## SERVICE INFORMATION BULLETIN

**TITLE :** Cheater glass seal rework

**DOCUMENT # :** 11 A 028

**AFFECTED VEHICLES :** 12C

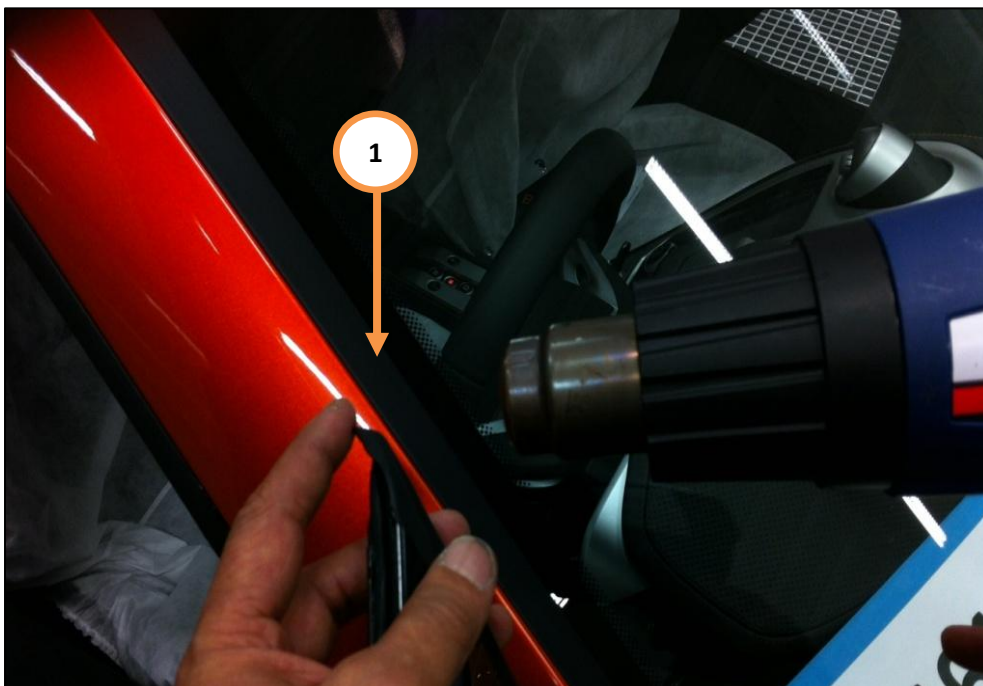
**SITUATION :** Quality Engineering at McLaren Automotive have identified an excessive gap between the cheater glass, the divider bar and the primary door seal. This will potentially result in water ingress into the cabin.

The above situation will only occur when a new cheater glass seal is fitted into a vehicle.

1. Once the new cheater glass seal (Part number 11A5300CP and/or 11A5301CP) has been fitted into the vehicle a heat gun must be used to complete the rework described below.
2. Set the heat gun to 170 degrees Celsius and open the affected door.
3. Position the heat gun approximately 150mm away from the tip of the cheater glass seal (1).

4. Apply heat for 15-20 seconds until the cheater glass seal can be moulded by hand.
5. Once the seal can be manipulated move the tip of the seal inboard until the seal is moulded approximately 45 degrees (2).

6. This condition creates a better contact between the cheater glass seal and the primary door seal when the door is closed, preventing water passing the seal and entering into the cabin.
